# Customer Satisfaction Program

## 17297 High Voltage Battery Pack Low Cell

Reference Number: N172104090

Revision: 03

5136764

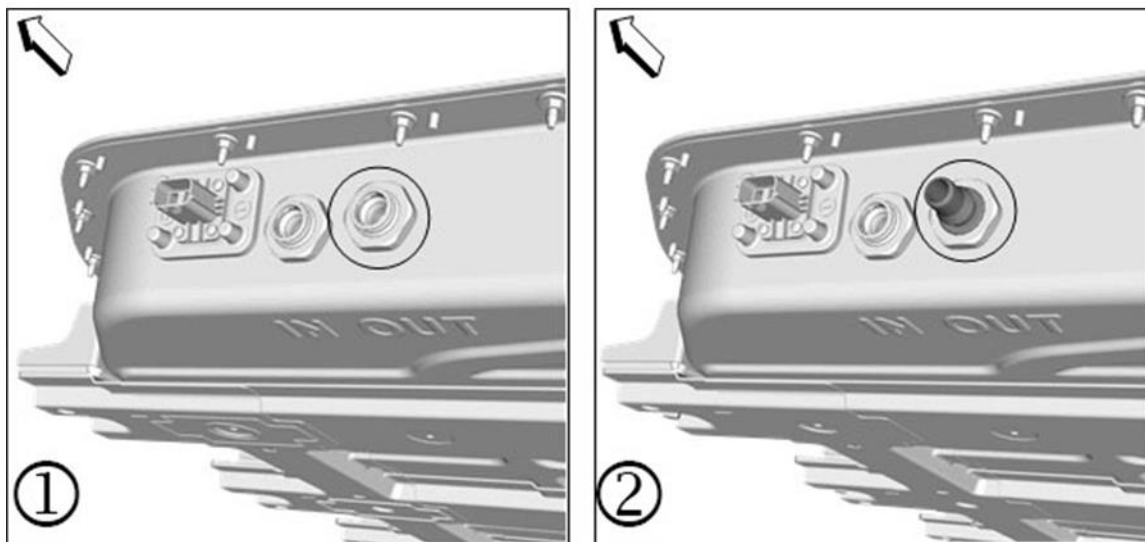
2. Determine the type of battery pack fitted to your vehicle by inspecting the battery pack coolant fittings at the rear of the battery pack. The old-style battery pack (1) has two female fittings, and the new style battery pack (2) has a male and a female fitting.
3. Replace the drive motor battery. Refer to the appropriate procedure below depending on the VIN and battery pack style.
  - *Drive Motor Battery Replacement and Shipping Preparation (New Design Battery Pack in Vehicles built before 1G1FX6S06H4163254).*
  - *Drive Motor Battery Replacement and Shipping Preparation (Old Design Battery Pack in Vehicles built before 1G1FX6S06H4163254) in SI.*
  - *Drive Motor Battery Replacement and Shipping Preparation (New Design Battery Pack in Vehicles built after 1G1FX6S06H4163254).*
